17 SUB2013-00054

IAIN FROST SUBDIVISION, RESUBDIVISION OF

APPLICATION NUMBER 17 DATE July 11, 2013

DETAIL SITE PLAN

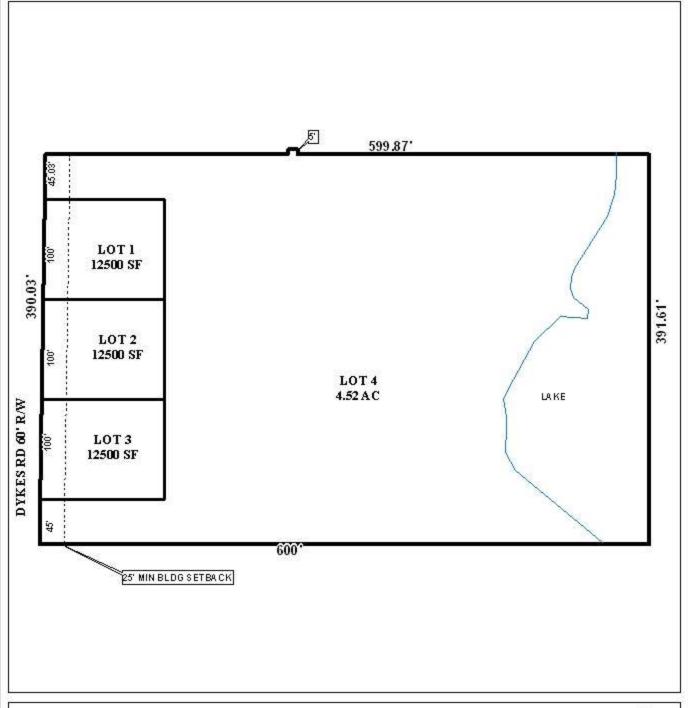
The applicant proposes that Lot 4 be a "flag" lot, with two proposed 45'± wide by 125'± long poles connecting the lot to Dykes Road South. The Planning Commission's previous approval in 2012 included this same double pole feature. Because of the previous approval, a wavier of V.D.1 may be appropriate.

It should also be noted that the proposed Lot 4 exceeds the 3.5 width to depth ratio recommended in Section V.D.3 of the Subdivision Regulations. As the plat was previously approved, a waiver of V.D.3 may again be appropriate.

The 25-foot minimum building setback is shown and labeled on the preliminary plat; however, the setback line for Lot 4 should be revised to illustrate it from where the poles meet the "flag". If approved the minimum building setback should be illustrated on the Final Plat.

If approved, a note should be placed on the Final Plat limiting lots 1-3 to one curb cut and lot 4 to two curb cuts to Dykes Road South with the size, design, and location of all curb cuts to be approved by Mobile County Engineering and conform to AASHTO standards.

As lot A is a flag lot, no future subdivision should be allowed until adequate frontage is provided.

- 1) depiction of minimum building setbacks where all lots are at least 60' in width on final plat;
- 2) placement of a note on the Final Plat stating that Lots 1-3 are limited to one curb-cut each, that Lot 4 is limited to two curb-cuts, and that the size, design, and location of all curb-cuts are to be approved by Mobile County Engineering and to comply with AASHTO standards;

- 3) placement of a note on the Final Plat stating that there shall be no future subdivision of Lot 4;
- 4) compliance with the Fire Department comments: "All projects within the City of Mobile Fire Jurisdiction must comply with the requirements of the 2009 International Fire Code, as adopted by the City of Mobile."
